P&Z CASE # _ SP2022-033 P&Z DATE July 12, 202	22 CC D	ATE Approved/Denied
ARCHITECTURAL REVIEW BOARD DATE	_HPAB DATE_	PARK BOARD DATE
Zoning Application  Specific Use Permit Zoning Change PD Concept Plan PD Development Plan		Copy of Ordinance (ORD#) Applications Receipt Location Map HOA Map
Site Plan Application  X Site Plan  Landscape Plan  Treescape Plan  Photometric Plan  Building Elevations  Material Samples  Color Rendering		PON Map FLU Map Newspaper Public Notice 500-foot Buffer Public Notice Project Review Staff Report Correspondence Copy-all Plans Required Copy-Mark-Ups
Platting Application  Master Plat Preliminary Plat Final Plat Replat Administrative/Minor Plat Vacation Plat Landscape Plan Treescape Plan		City Council Minutes – Laserfiche Minutes-Laserfiche Plat Filled Date
HPAB Application  Exhibit		
Miscellaneous Application  Variance/Exception Request	Zoning	Map Updated

PROJECT NAME: Site Plan for Dunkin' Donuts

CASE CAPTION: Discuss and consider a request by John Gardner of Kirkman Engineering for the approval of a Site Plan for a Restaurant with Less

DEPARTMENT	REVIEWER	DATE OF REVIEW	STATUS OF PROJECT	
PLANNING	Henry Lee	06/24/2022	Needs Review

**SITE PLAN**

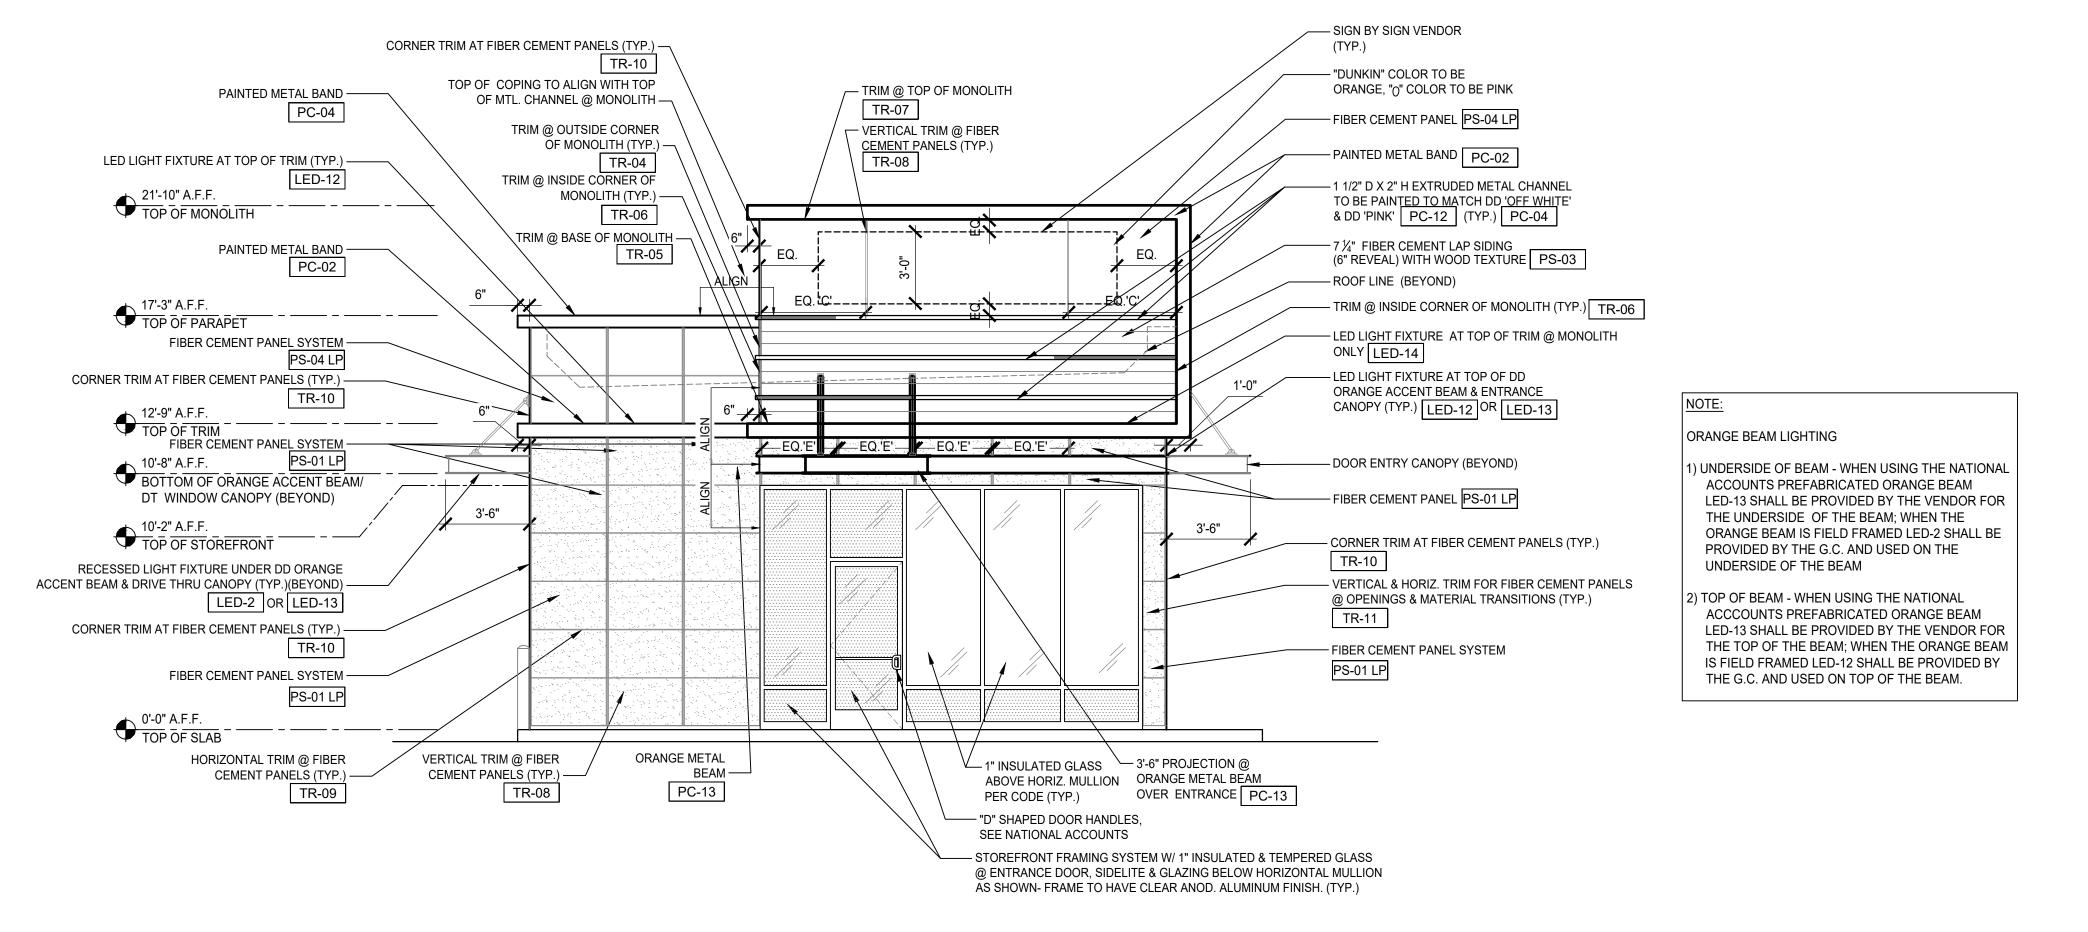
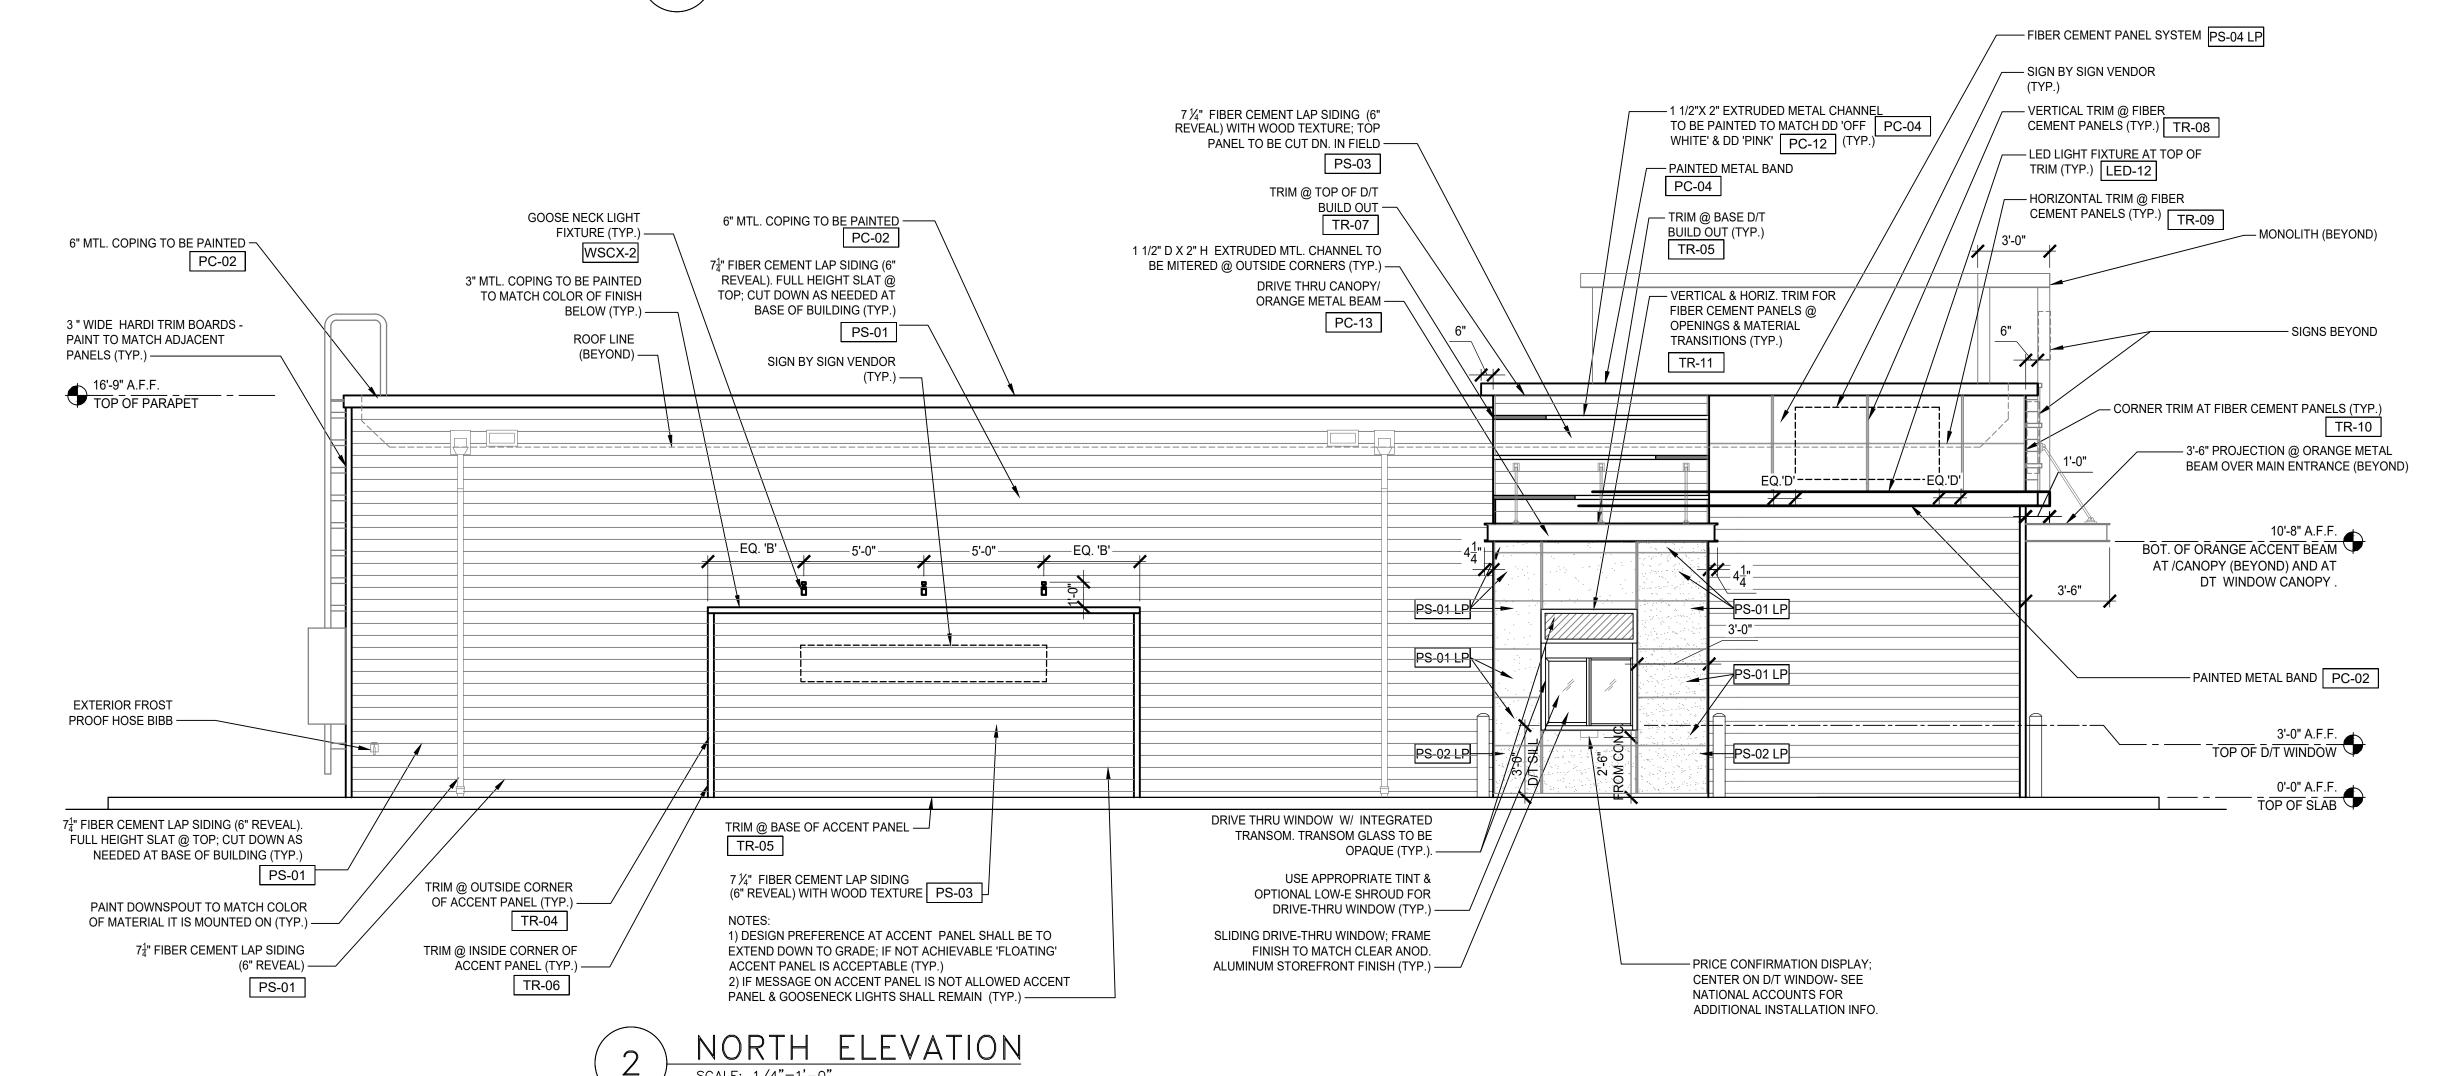
#### M.7 Site Plan:

- 1. The building square footage varies between the site data table and the callout. Please verify which one is accurate and make them consistent. (Subsection 03.04. B, of Article 11)

- 2. The front building setback is 25-feet. Please correct the site plan to reflect this. (Subsection 03.04. B, of Article 11)
- 3. Please indicate all drive/turn radii. (Subsection 03.04. B, of Article 11)

- 6. Remove signage on the site plan. Signage is covered by a separate permit at the time of building permit. (Subsection 06.02. F, of Article 05)
- 7. Indicate any ground mounted utility equipment and the subsequent screening. (Subsection 01.05. C, of Article 05)

- 8. Indicate any roof mounted utility equipment and crosshatch it on the building elevations. (Subsection 01.05. C, of Article 05)
- 9. Dumpster Screening. The masonry screening wall must be 8-feet in height because the property is located in an overlay district. The gate must be self-latching and not manual. The dumpster enclosure must be faced in the same material as the primary building. The enclosure must have 5-gallon shrubs planted around it. (Subsection 01.05. B, of Article 05)
